REFERENCE:	Nova Bus Manuals
SECTION:	12: Interior Furnishings
RS N°:	MQR 7621-849
EFFECTIVE IN PROD.:	N/A

SUBJECT:	Bum rest shells replacement
JUSTIFICATION:	Bum rest shells cracking and anchor points may loosen with time and vibration.

Figure 1 - Front and Rear Bum Rest Views

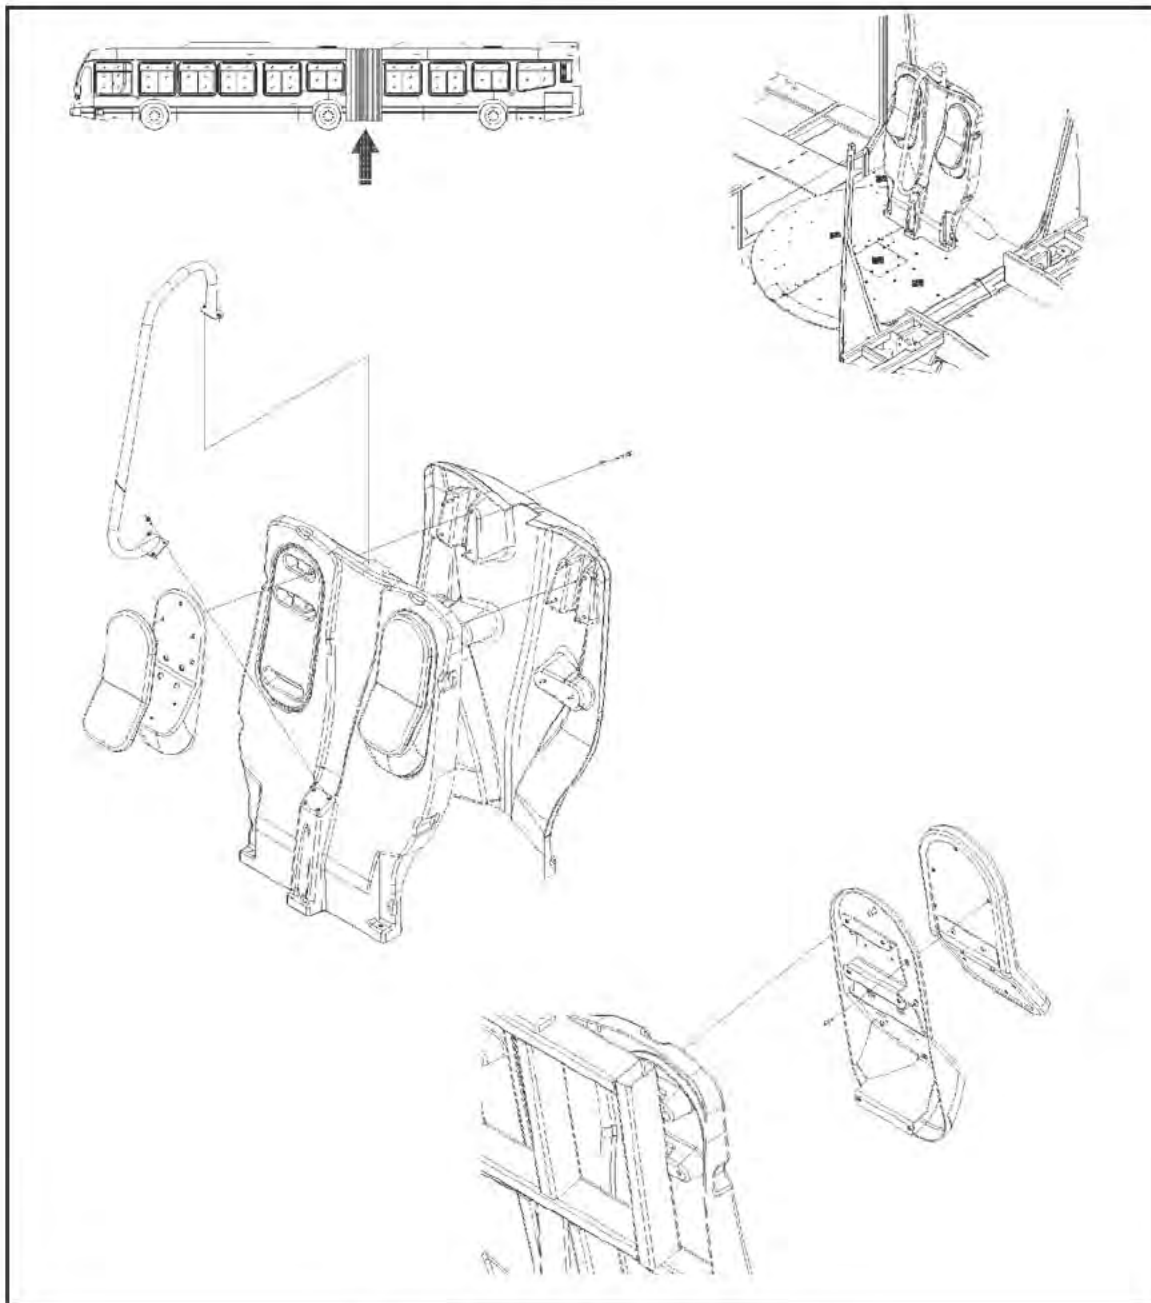
- 1.1. Remove the front and the rear bum rest shells. Retain the removed parts. See Figure 1.

Figure 2 - Hardware Location

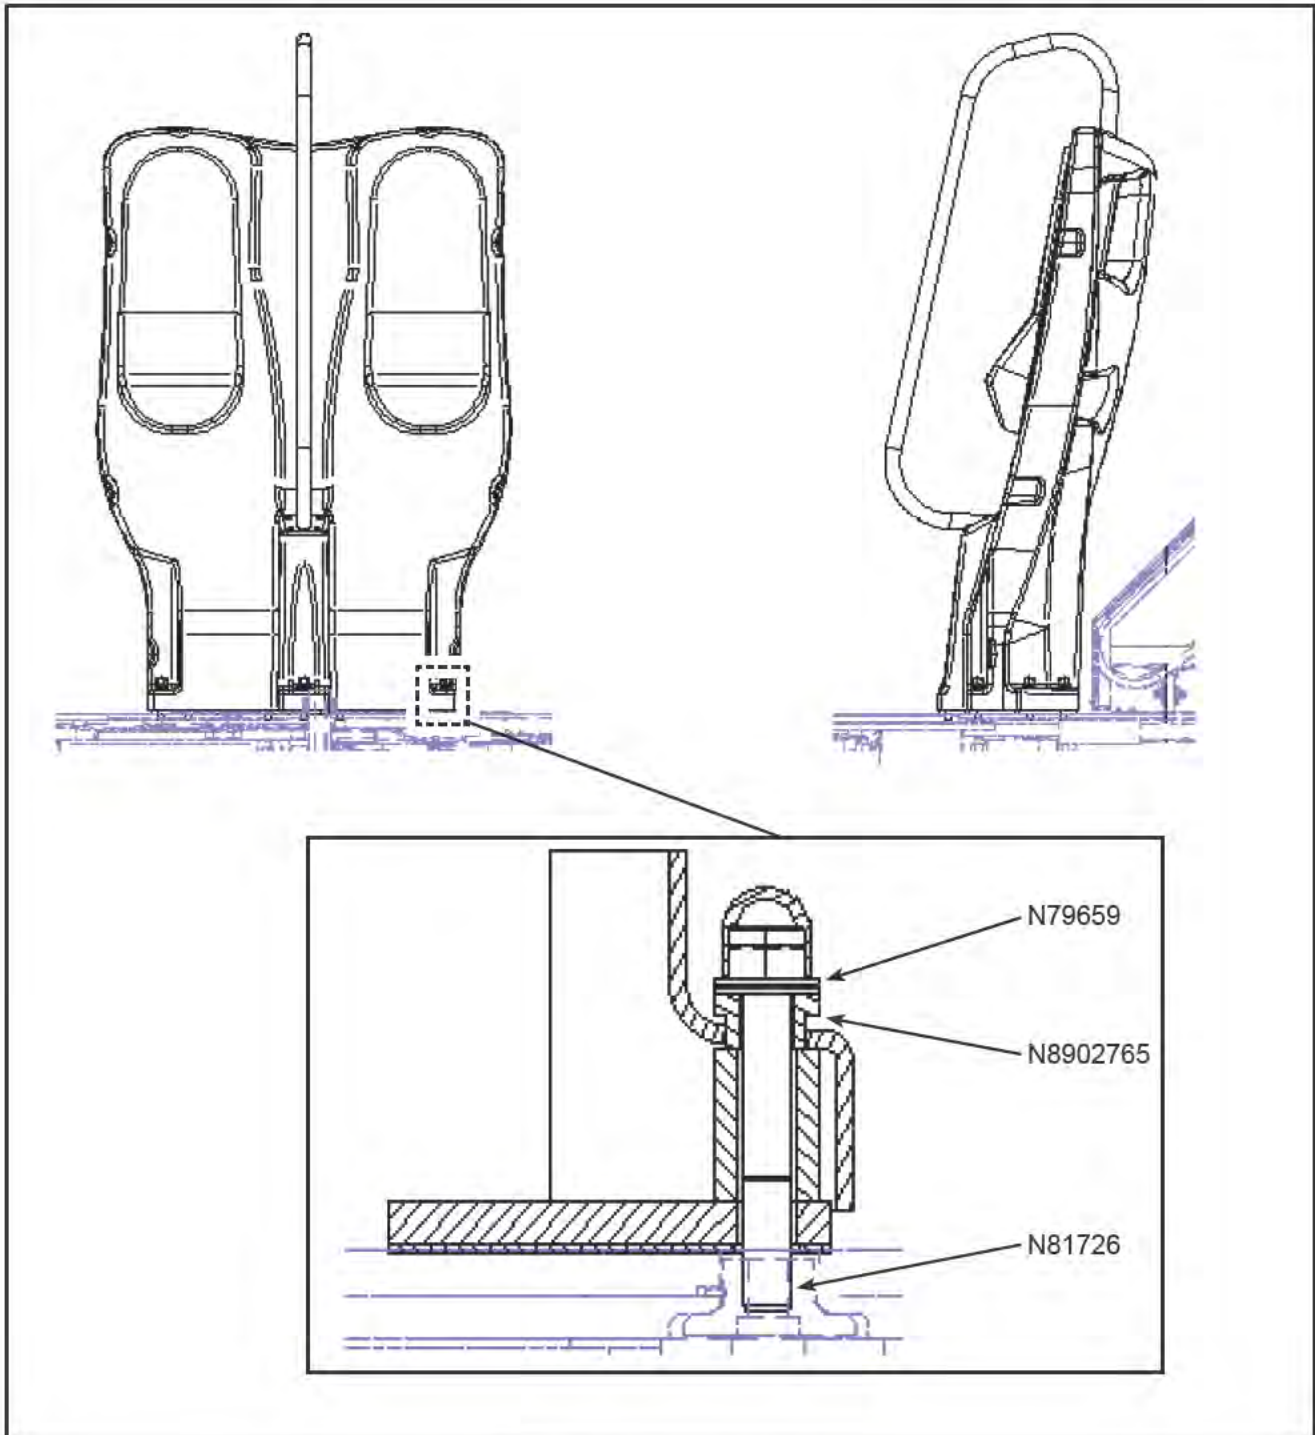
- 1.2. Install the new bum rest shells using the new bushing N8902765, self-locking washer N79659 and screw N81726. Torque to 30.2 lb-ft (41 N•m). See Figure 2. Typical for 7 locations.
